# “Flooding in the Mekong Delta: Impact of dyke systems on downstream hydrodynamics” by Vo Quoc Thanh et al.

## Responses to Referee #2’s comments

Figure 1. The modelling grid. The floodplains are defined as 2D grids (in black) and canals are defined as 1D networks (in pink). The connecting links of 1D network and 2D grids are in blue.

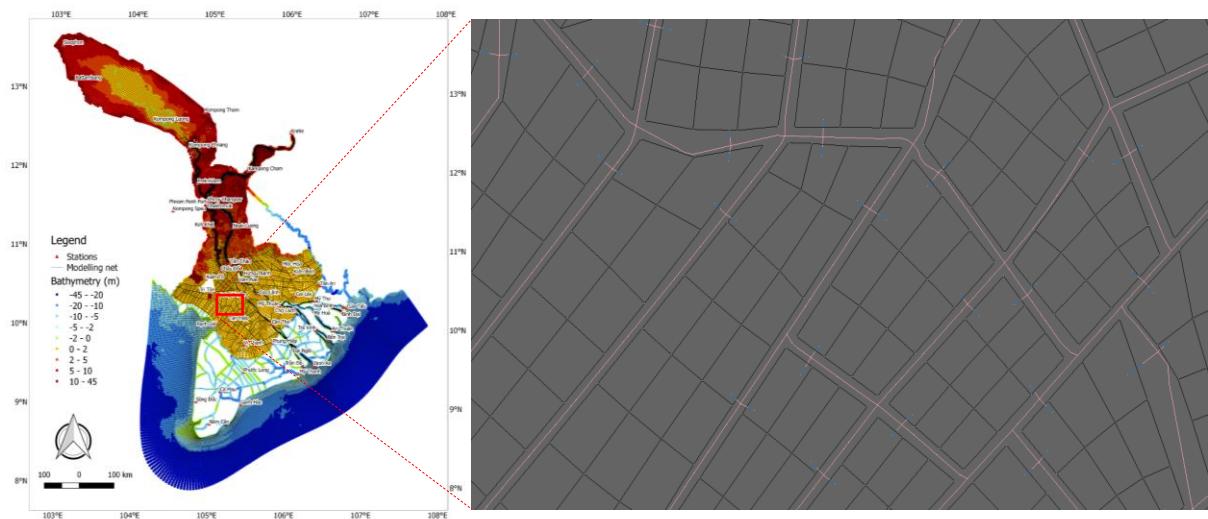
- *High dyke geometry should be described (design return period, crest elevation, precise location etc.) and how they were incorporated into the computational mesh.*

**Authors' response:** The dyke geometry is various, as presented in the Figure 4 in the manuscript. The dyke geometries depend on the canal network. According to the Department of Agriculture and Rural Development of An Giang province, the high dykes are built, with their crest levels are higher than the peak water level of the flood 2000. Thus a high dyke in computation is defined as 2D dry grids. This modelling approach of floodplains and canals is based on field observations, as presented in Figure 1 and Figure 2.
